AUSTRALIAN PARACHUTE FEDERATION

APF SERVICE BULLETIN No APF981001-A

SUBJECT: MAIN CONTAINER CLOSING LOOP GROMMET

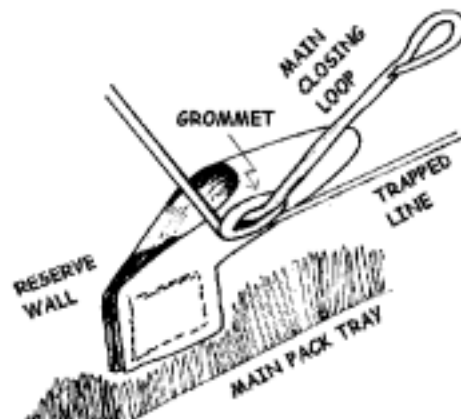
BACKGROUND: There have now been two incidents in Australia one on a Talon and one a Vector (and one in the USA on a Mirage) where a main canopy rigging line has hooked under the edge of the grommet and resulted in a main-in-tow despite being cut away. In both Australian cases the reserve was used and cleared the main.

There are a number of other brands of equipment manufactured this way, some with the grommet facing the reserve wall, some with the grommet facing the main bag that could be susceptible to this.

APF POLICY: The APF requires all dual container systems incorporating a grommet on a webbing retainer facing the main bag, in order of preference, to:

1. have the retainer with grommet removed and the loop fixed to a closing flap grommet, or
2. have the retainer turned over or have the grommet removed and installed the other way (facing the reserve), or
3. have the grommet covered by sewing a piece of material around 3 sides of the grommet face.

A Packer "A" may do the work if it can be accomplished by hand tacking. A Rigger must do the work if it requires a sewing machine.
